SHR-359

When was Steamboat Slough last recalibrated for DSM2 bathymetry?  
 Is that data reflected in the current Waterfix estimates for impacts to  
 flow and water quality?

1  
 2 **Figure A-12: North Delta DSM2 grid used in the BDCP Modeling (NOTE: Intake locations**  
 3 **slightly modified in Chapter 3: Description of Alternatives)**  
 4  
 5

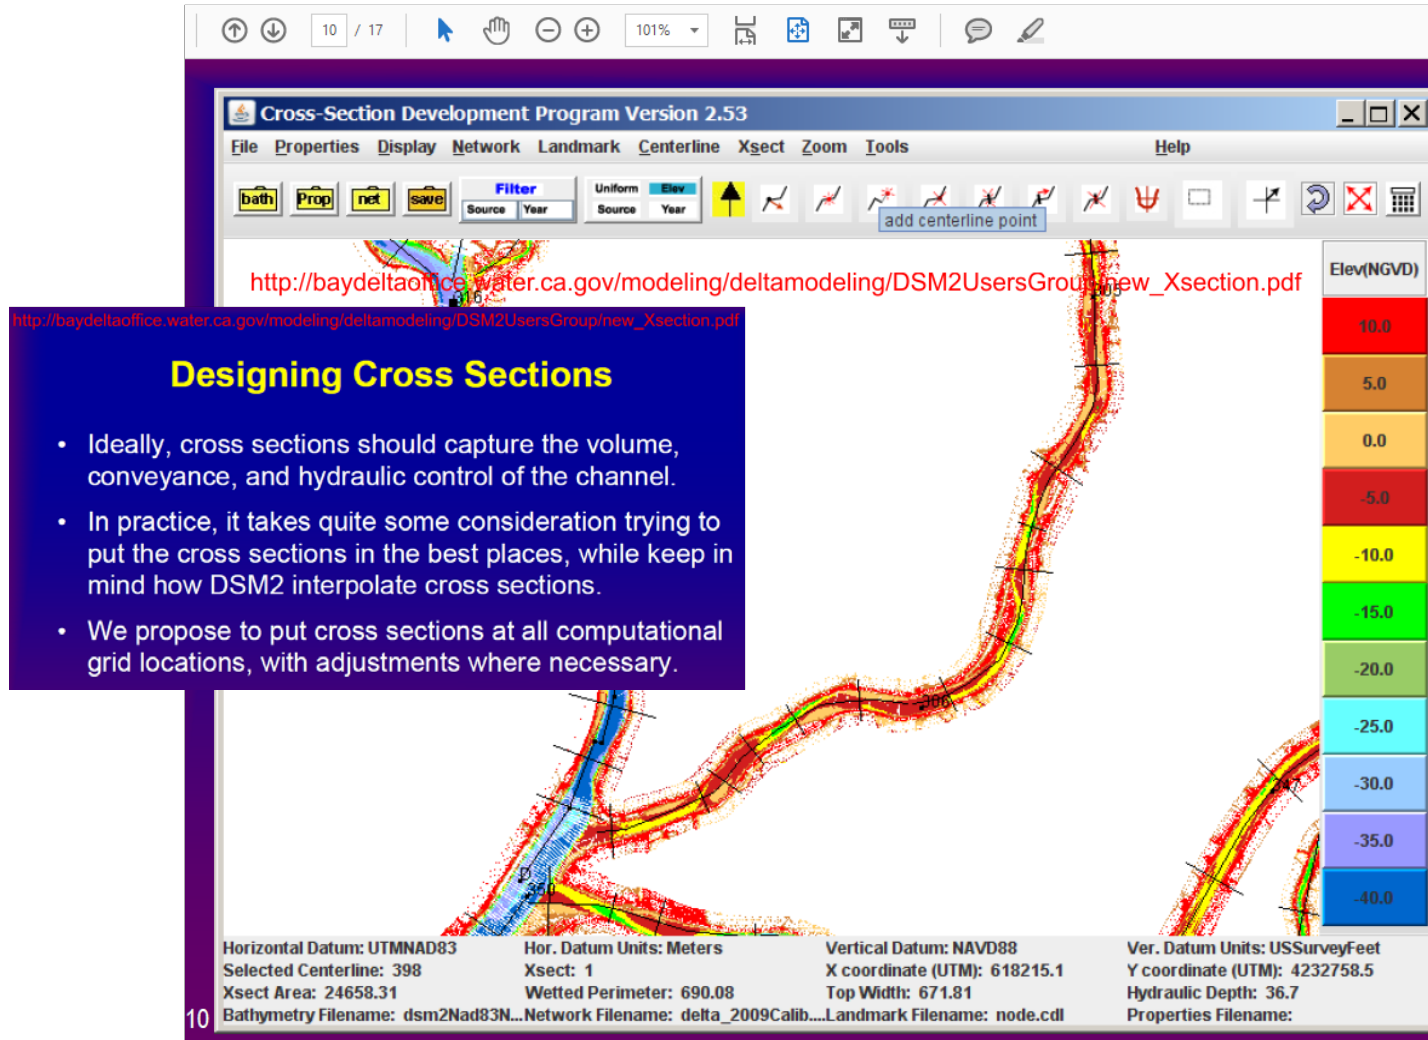
Who determines where the cross sections go? What is the goal of determining cross sections?  
 Note the graphic shows elevation and not water depth. What if water depth and/or elevation is off by 25% or more?

[snugharbor.net/images-2014/news/barriers/steamboatsloughdepth.JPG](http://snugharbor.net/images-2014/news/barriers/steamboatsloughdepth.JPG)

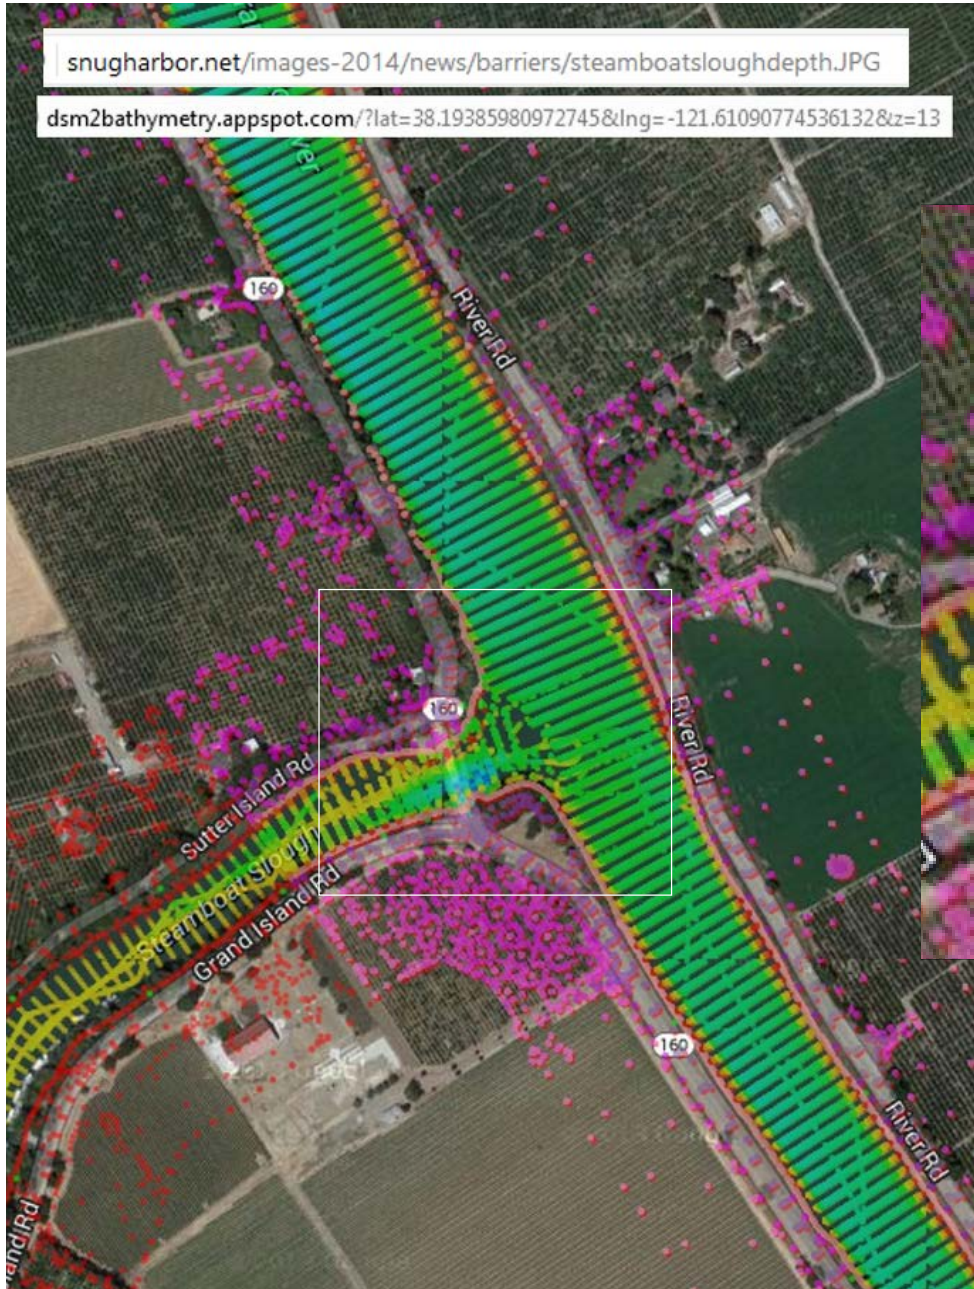
Here is an example of the survey results that used to be available online. Screen print was made by NSS and preserved at the Snug Harbor link as noted in the screen print.

Who decided what cross section to use at the north end of Steamboat Slough?  
Would it be important for DSM2 to represent any barriers to flow in order for the model to accurately predict impacts from reduced flows?

Bathymetry from 2008, as provided by Paul Marshall of the Delta Barriers planning branch, shows a subsurface flow barrier at the north end of Steamboat Slough. Was a cross section representing this subsurface flow barrier added to DSM2 in the 2016 recalibration?

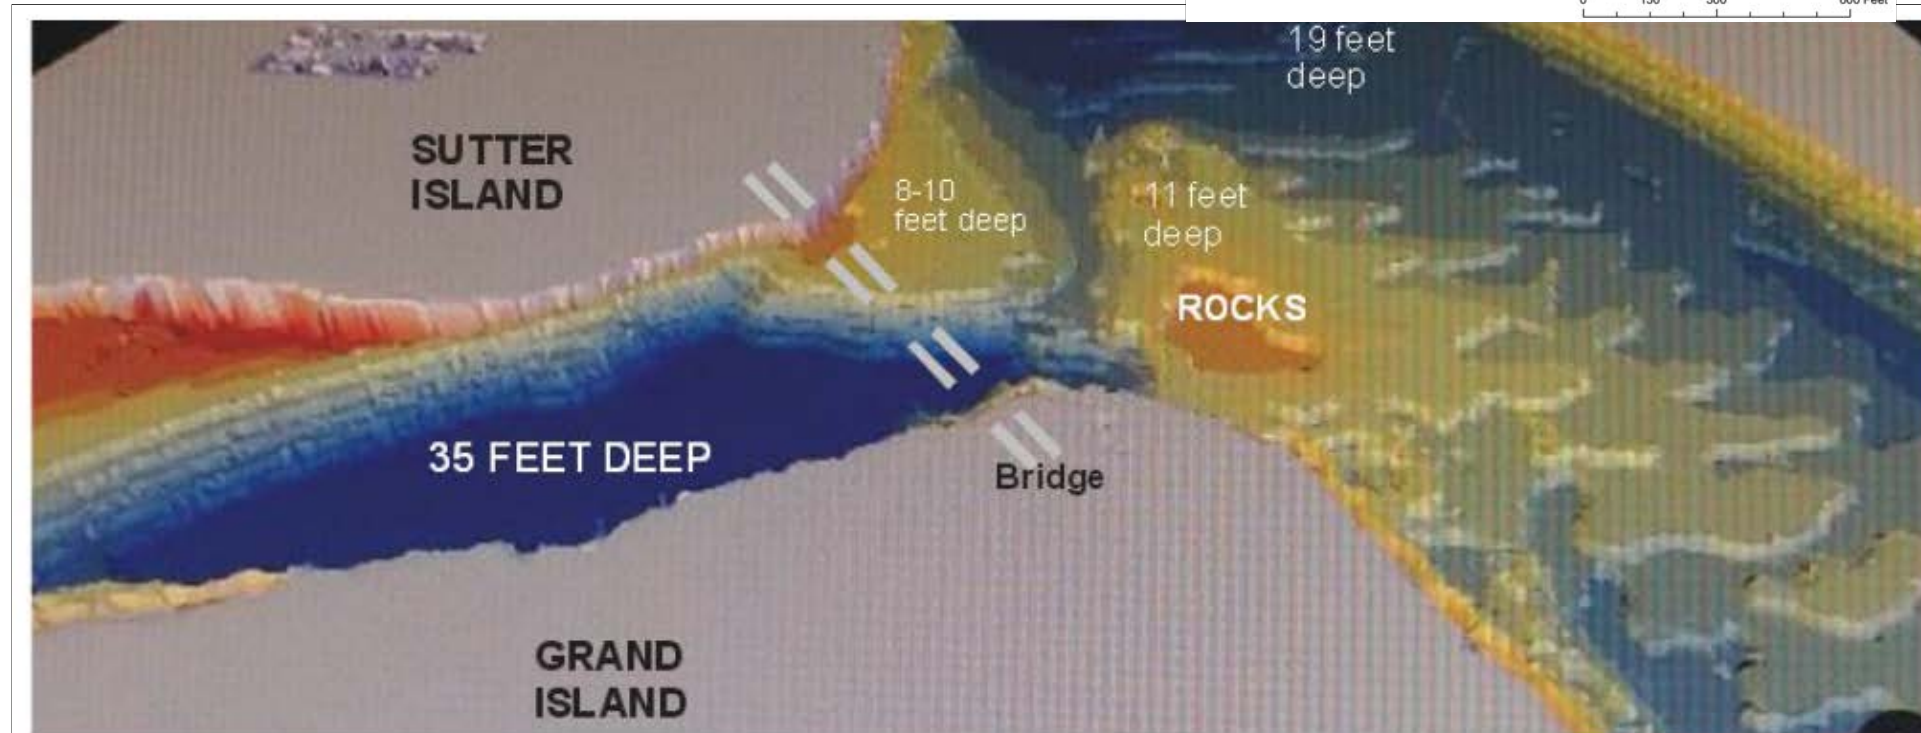
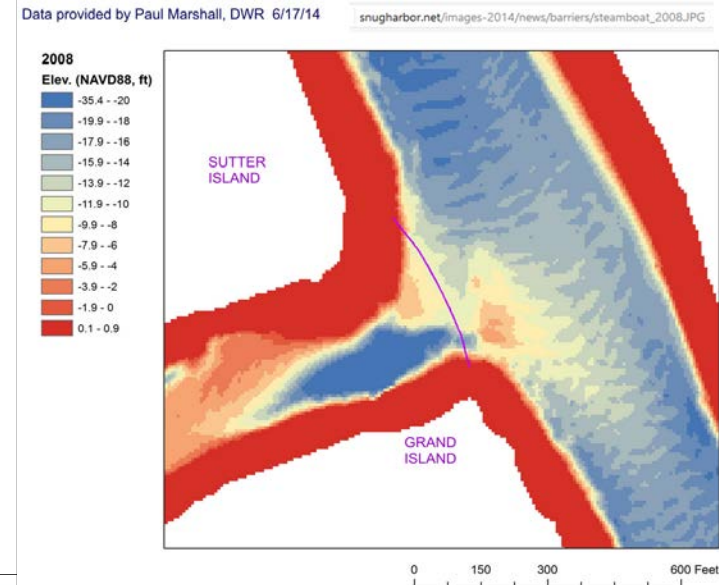
More important, what version of DSM2 is Waterfix effects analysis based upon and if it does not reflect correct channel depths for Steamboat Slough how might that change the effects outcomes?

Figure 5C.4-27. Bench Habitat Analysis Sites

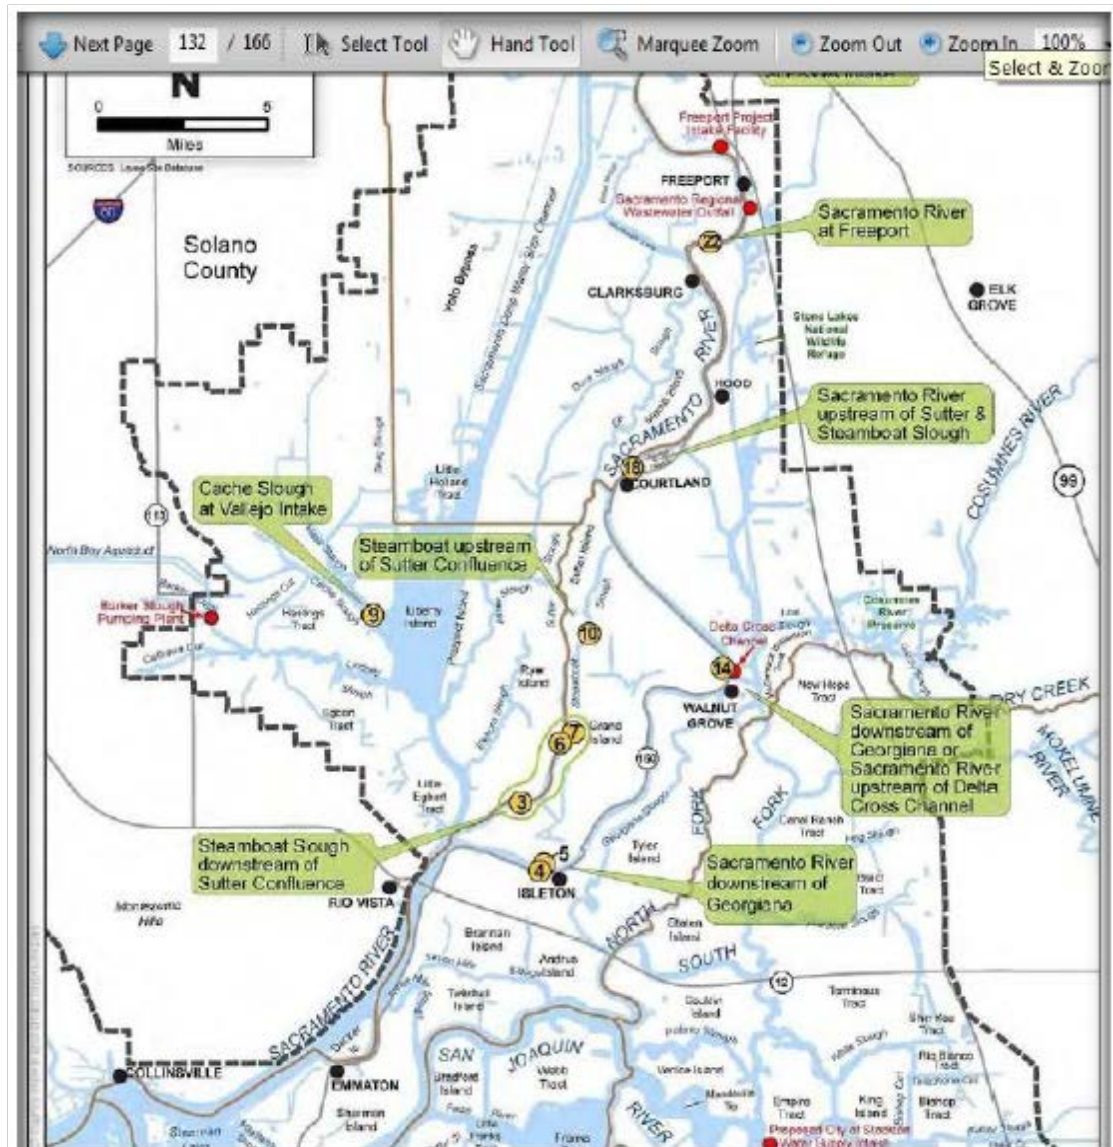
Have the cross sections of DSM2 been recalibrated to reflect the reduced channel width at the BDCP restoration sites on lower Steamboat Slough which effectively reduced channel width by at least 100 feet, thereby reducing flood flow capacity?

10-sediment insertion and bench test resulted in raising bed of waterway  
 6,7 Large trees placed in waterway near banks to capture sediment & reduce waterway navigation and use in this area  
 3 bench built up and planted with tules but was infested with egeria densa which

Figure 5C.4-27. Bench Habitat Analysis Sites

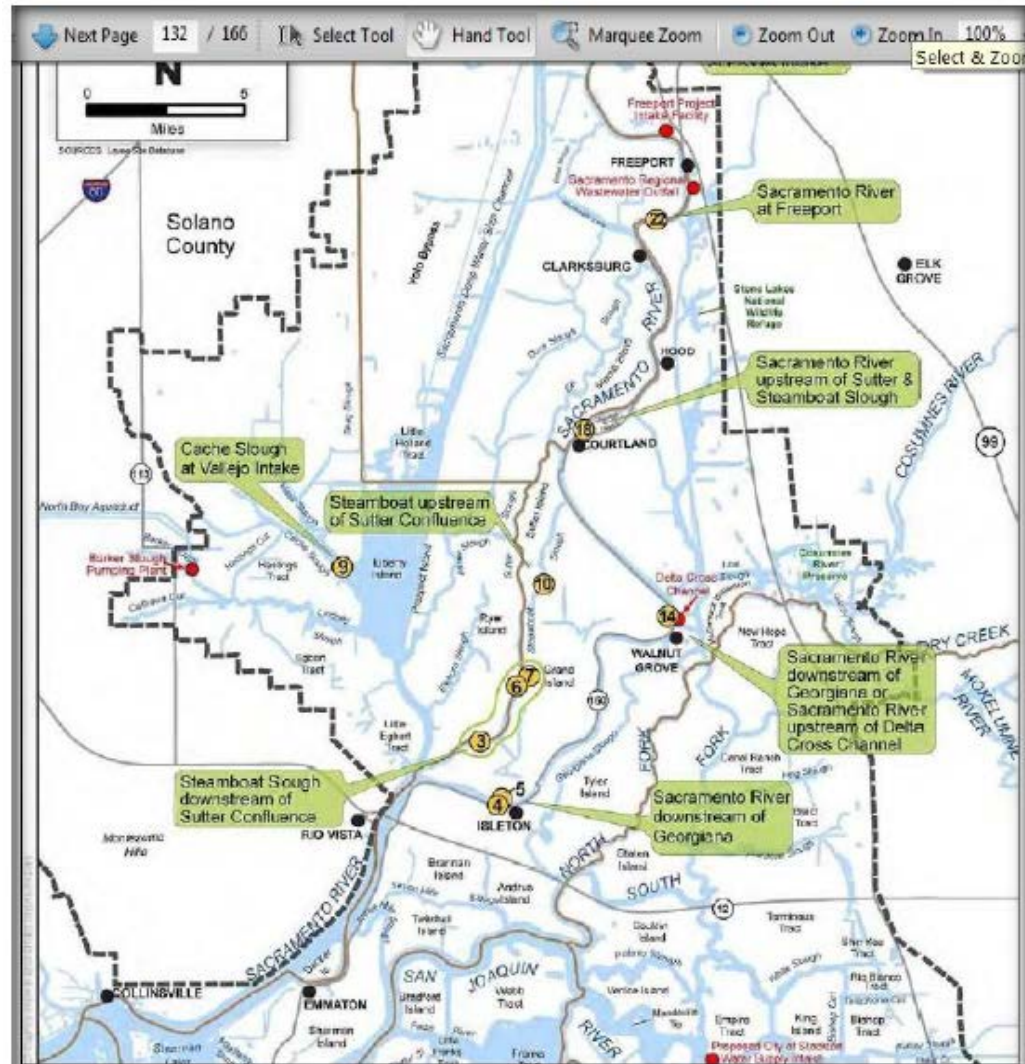
Have the cross sections of DSM2 been recalibrated to reflect the reduced channel width at the BDCP restoration sites on lower Steamboat Slough which effectively reduced channel width by at least 100 feet, thereby reducing flood flow capacity?

10-sediment insertion and bench test resulted in raising bed of waterway  
 6,7 Large trees placed in waterway near banks to capture sediment & reduce waterway navigation and use in this area  
 3 bench built up and planted with tules but was infested with egeria densa which is not suitable for salmonids. Also causes flood control issues as bench reduces water outflow in high flow times.
